This addendum is issued for the purpose of clarifying, amending or revising certain information contained in the DGSSMS Documents. This Addendum No. 1 shall form an integral part of the DGSSMS Documents, **and as such has been attached to the document.**

3. Remove SSMS E2-17 from the 2021 DGSSMS Update and replace it with attached modified E2-17

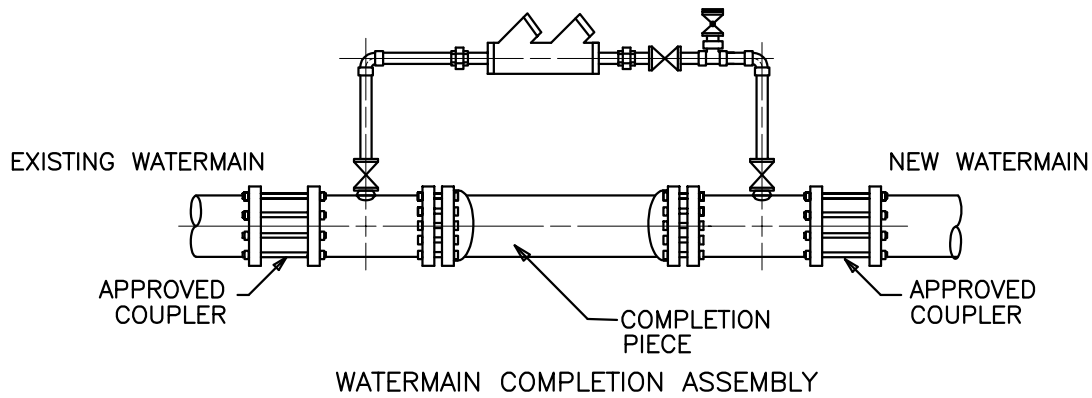
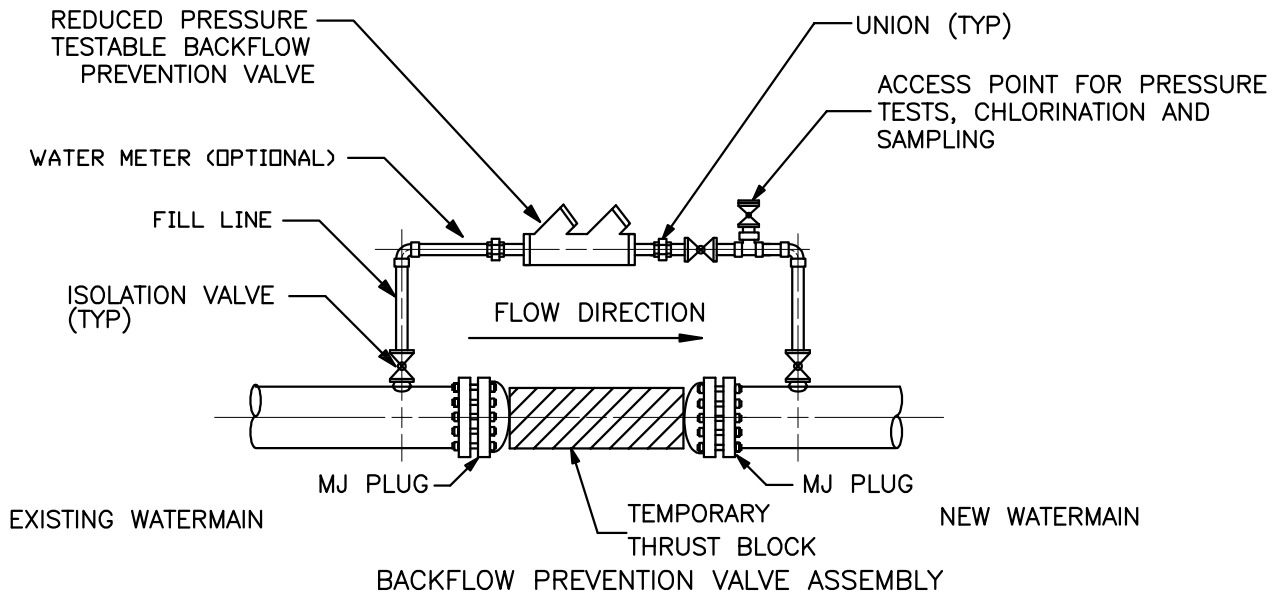
To facilitate watermain commissioning, a temporary connection to the existing water distribution can be made through the use of a temporary or “jumper” connection equipped with a backflow preventer as detailed in the SSMS standard drawing E2-17. The connection to the existing distribution system shall be done in a secure location and be vandal and tamper resistant and shall be no larger than 50 mm diameter. Multiple jumpers or larger connections are acceptable with the approval of the Chief Municipal Engineer.

The backflow preventer shall be ~~a double check~~ or a reduced pressure type assembly and shall be installed, maintained, and field-tested in accordance with the latest edition of CAN/CSA-B64.10.
